Re: Request for TAC Meeting
Ryan Trust
221 Woodbury Ave, Tax map 175-10
General Residence A Zoning

221 WOODBURY AVENUE
PORTSMOUTH, NH 03801
SUBDIVISION PROPOSAL PLAN
TAC MEETING
OWNER- RYAN TRUST
OCTOBER 6, 2026

Re: TAC Work Session Notes & Follow-up Comments
Ryan Trust
221 Woodbury Ave, Tax map 175-10
General Residence A Zoning

Subject: Follow-up & Clarification: August 11th TAC Work Session – 221 Woodbury Ave

EXISTING SITE
PLAN

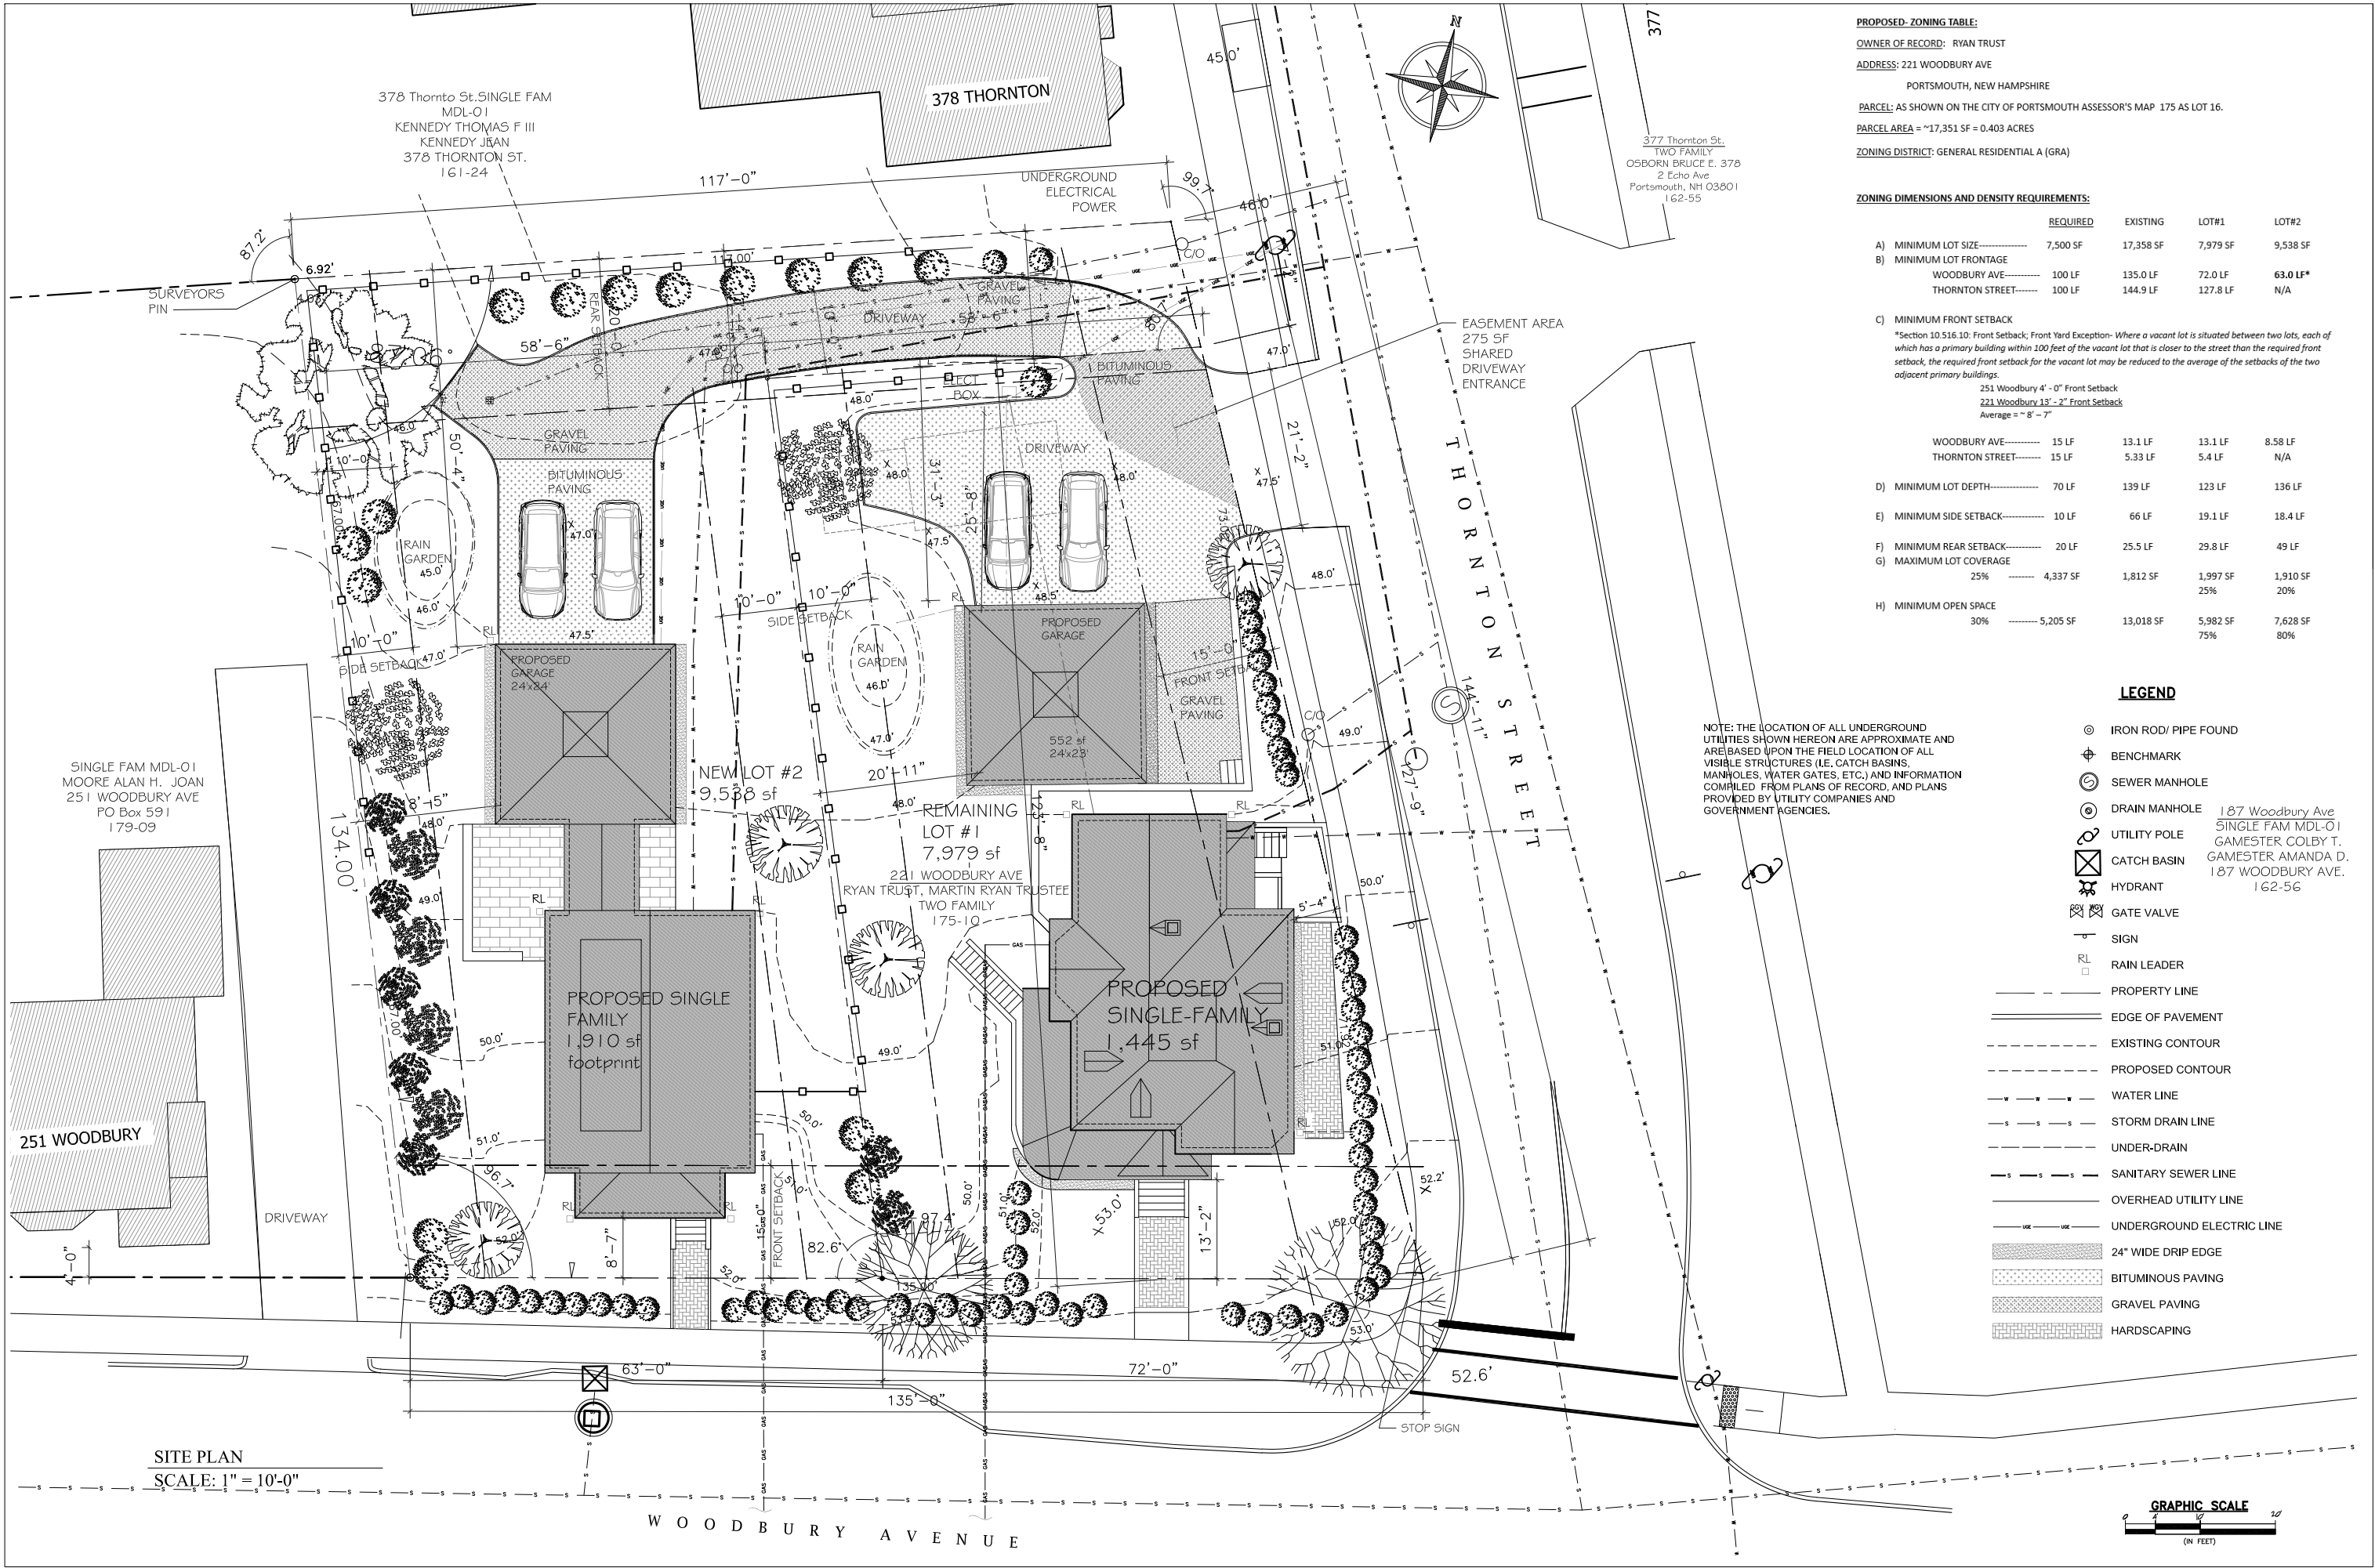
- Conflicting SF. Information (Ref. 9:59 Timestamp): Reconcile the square footage discrepancy between the existing conditions plan and the proposed architectural drawings. *(Status: Correction Pending)*

PROPOSED SITE
PLAN

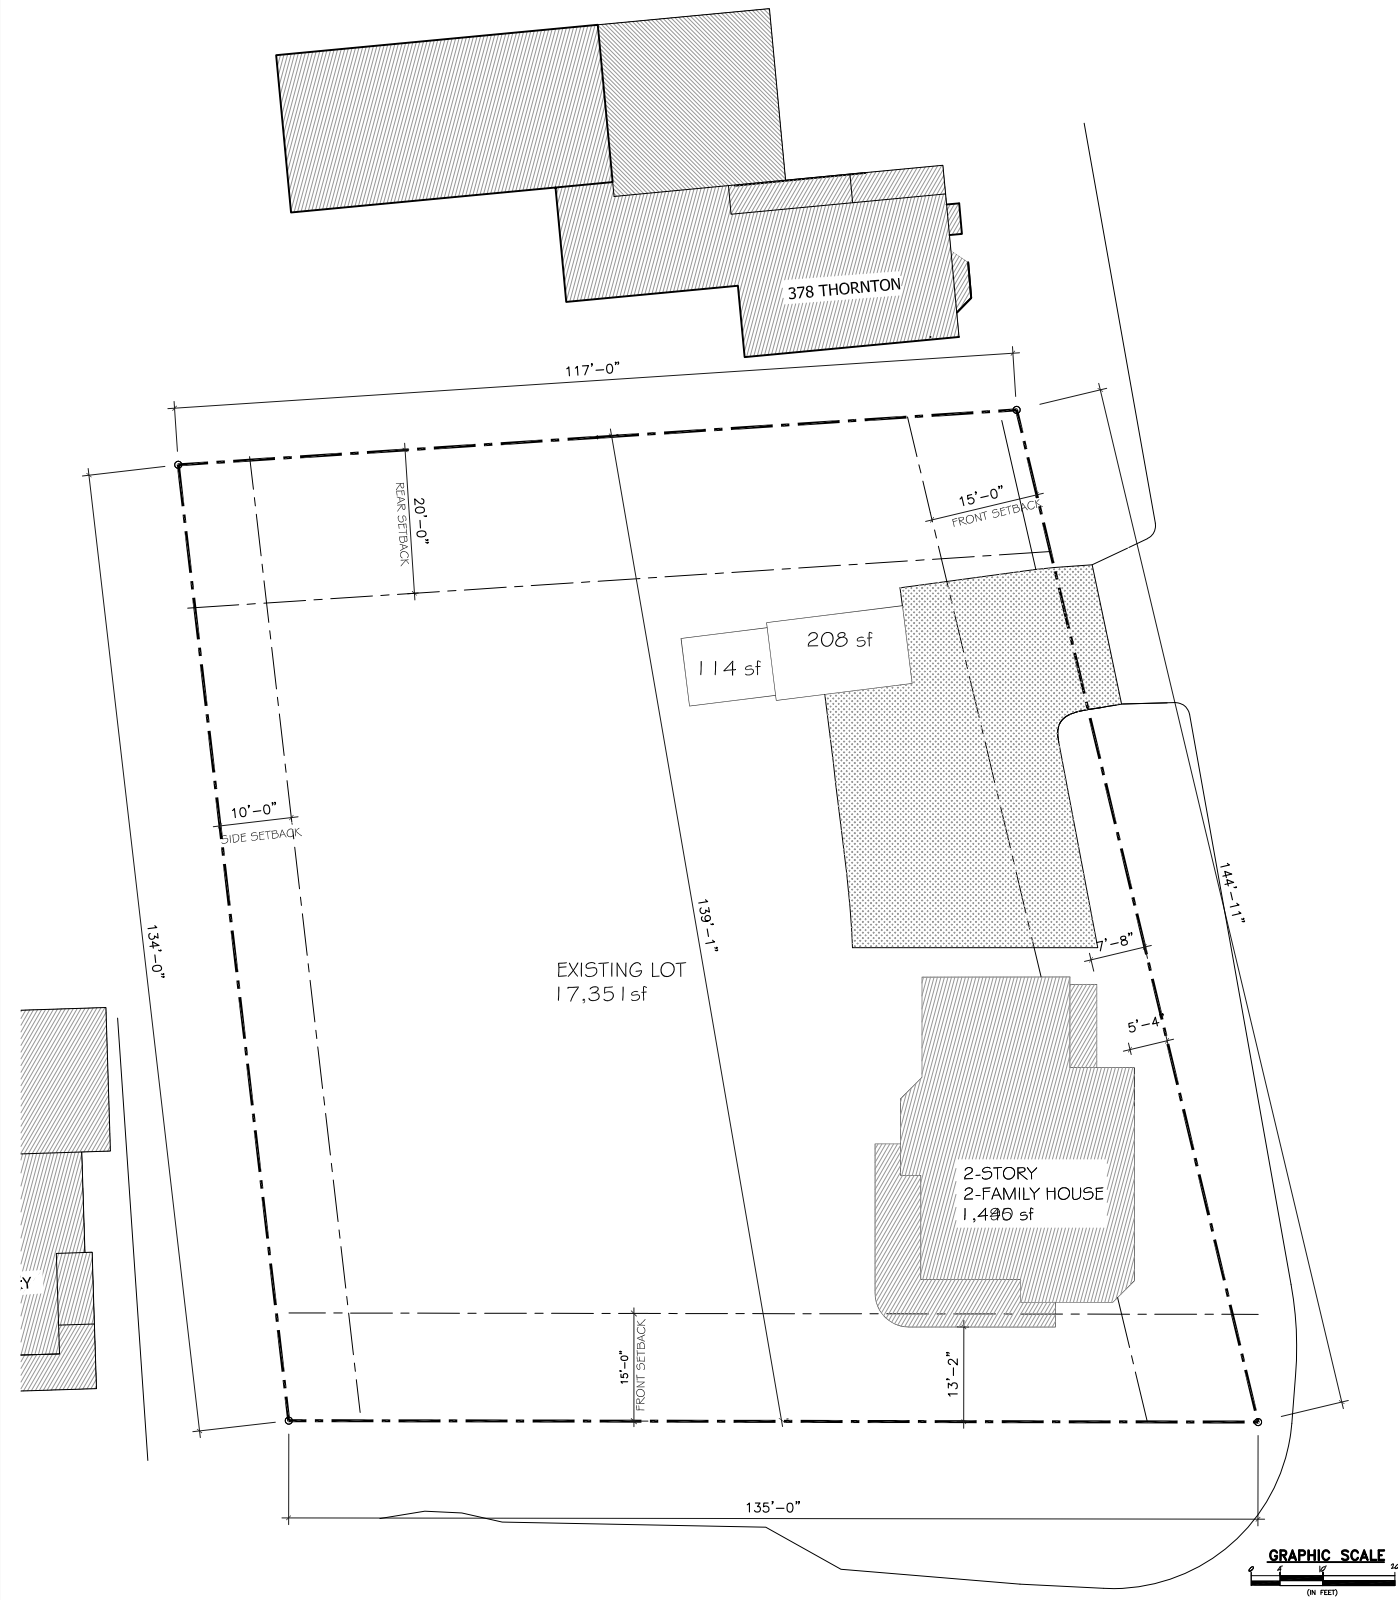
- Storm Water Line (Ref. 7:14 Timestamp): Update site plans to graphically illustrate the connection of the on-site stormwater line to the municipal stormwater main. (*Status: Confirmed*)
- Signage at Driveway (Ref. 7:33 Timestamp): Install a directional sign at the curb cut clearly listing all addresses served by the shared driveway. (*Status: Confirmed*)

- Zoning Tables (Ref. 10:05 Timestamp): Incorporate a complete zoning compliance table directly onto the site plan sheets. *(Status: Confirmed)*
- Stamped Survey (Ref. 10:42 Timestamp): During the session, the requirement for a stamped survey was discussed to proceed with the approval process. A surveyor has been retained to confirm the existing site and the proposed site plan.

*Section 10.516.10: Front Setback; Front Yard Exception- Where a vacant lot is situated between two lots, each of which has a primary building within 100 feet of the vacant lot that is closer to the street than the required front setback, the required front setback for the vacant lot may be reduced to the average of the setbacks of the two adjacent primary buildings.

251 Woodbury 4'-0" Front Setback
221 Woodbury 13'-2" Front Setback
Average = ~ 8' - 7"
